CITY PLAN COMMISSION STAFF REPORT

Indiana Commons at Staley Corners East

CD-CPC-2024-00142
Rezoning without Plan

CD-CPC-2024-00143
Non-Residential Development Plan

A200

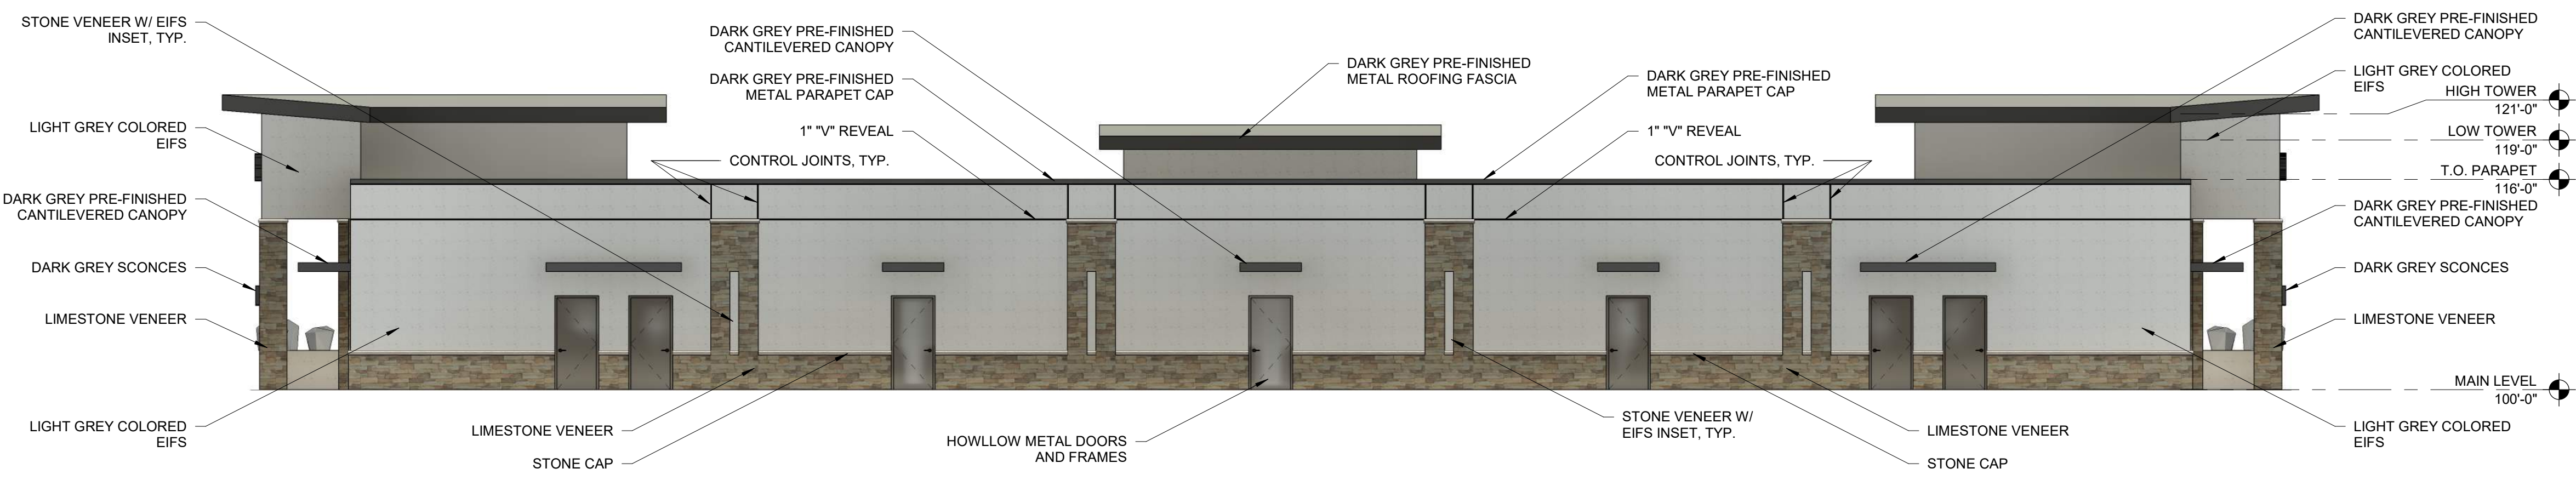
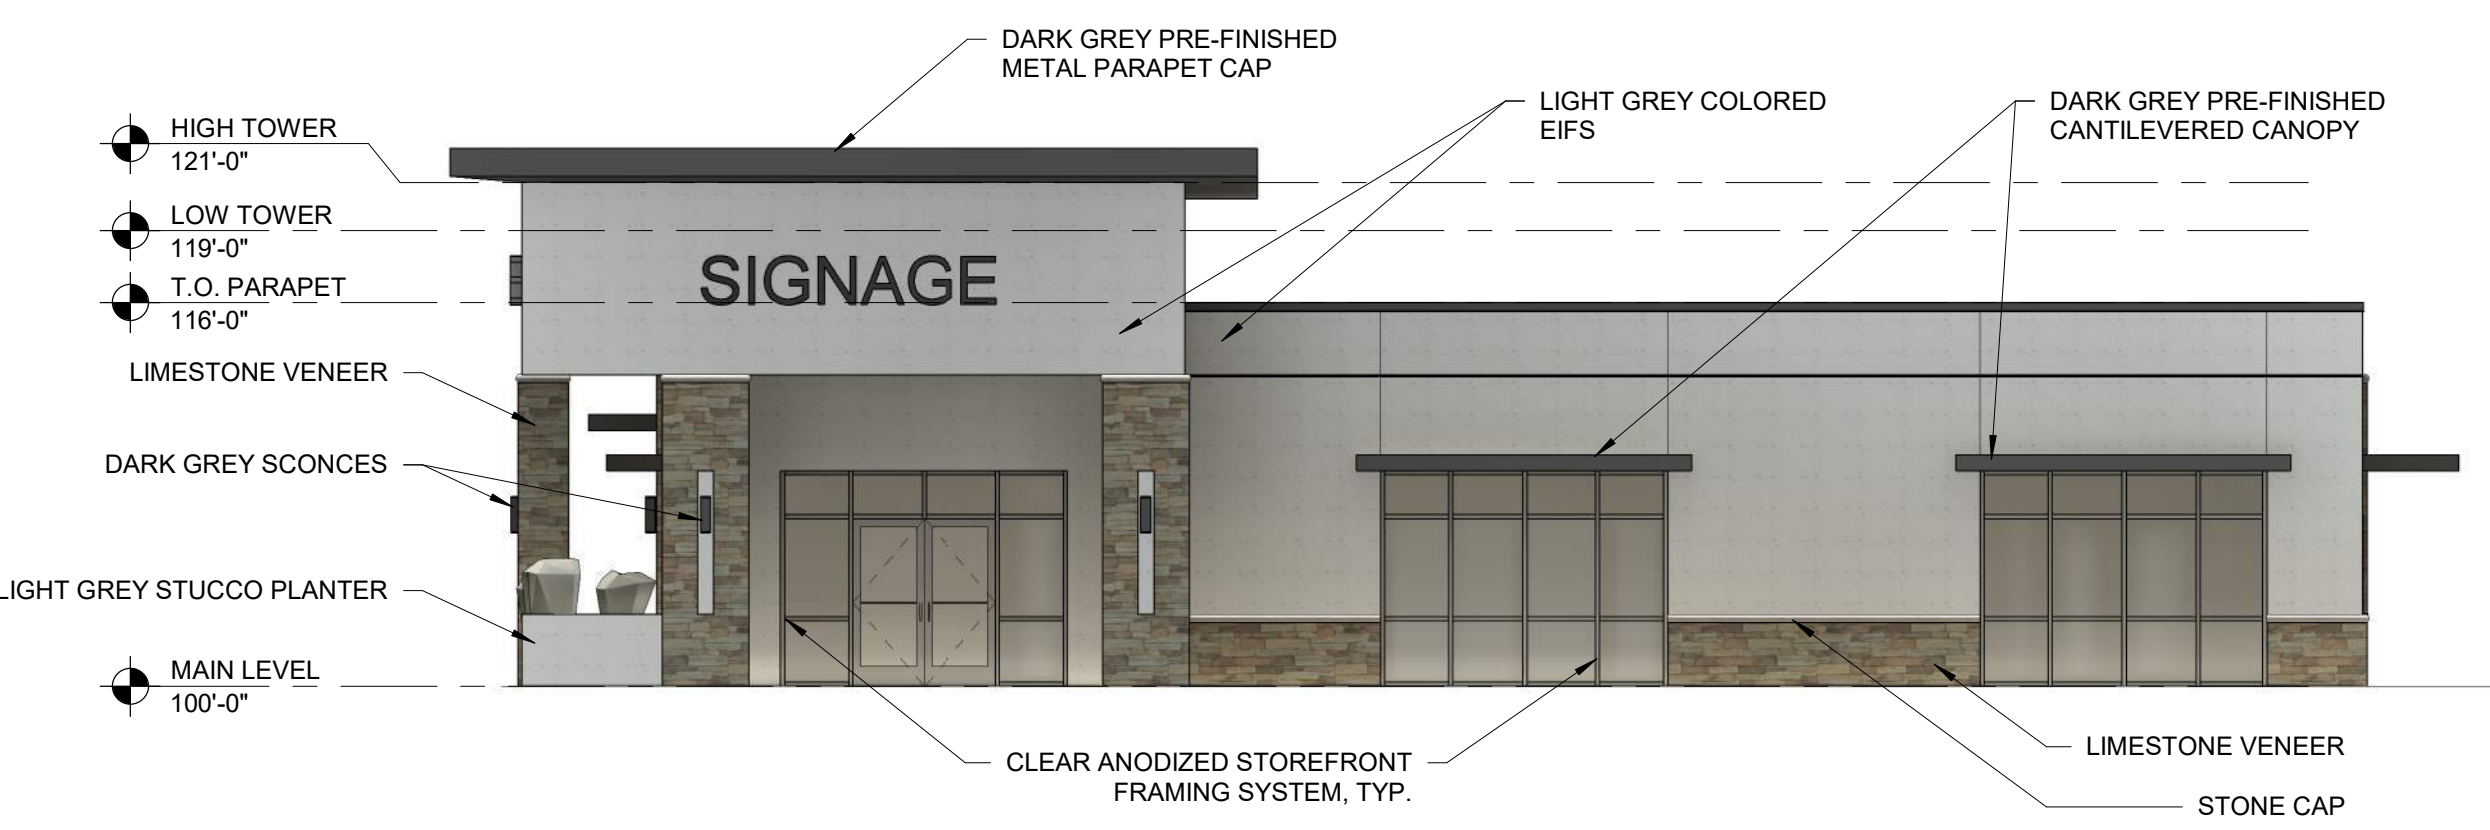
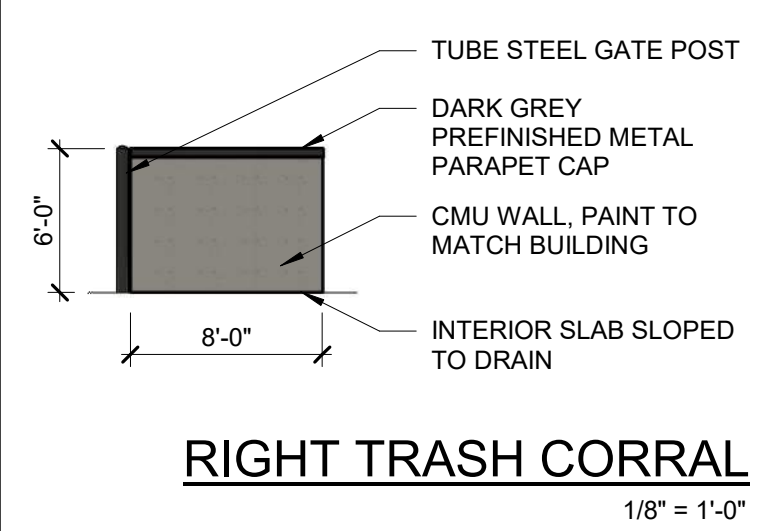
The applicant is proposing two identical commercial structures that primarily consists of an EIFS façade, limestone veneer and cantilevered canopies throughout.
